**Appendix J**  
Concession Space Requirements and Concession  
Program

**SUBJECT:** *Concession Space Requirements for LFMP*

**Figure 1**  
**Concession Space Requirements (SF per 1,000/Enplanements)**

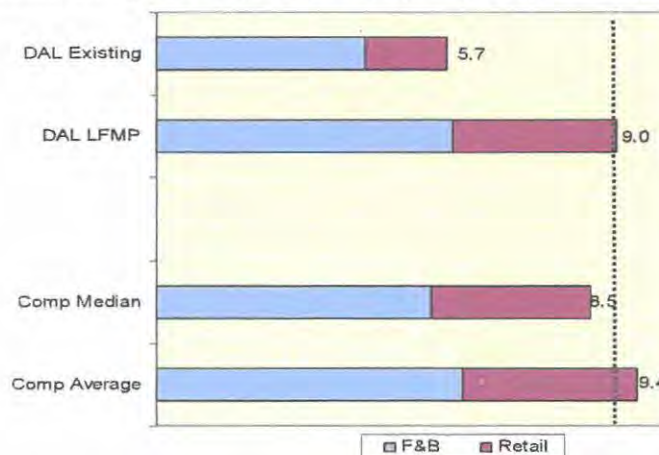
Unison's concession space requirements for the LFMP is 9.0 square feet per 1,000 annual projected enplanements, which is based on an analysis of facility, passenger, and concession characteristics for the new terminal. This number is in line with other medium hub airports. Our analysis of 23 comparatively sized airports indicates optimal concessions are sized between 8.5 to 9.4 square feet per 1,000 annual enplanements (Figure 1).
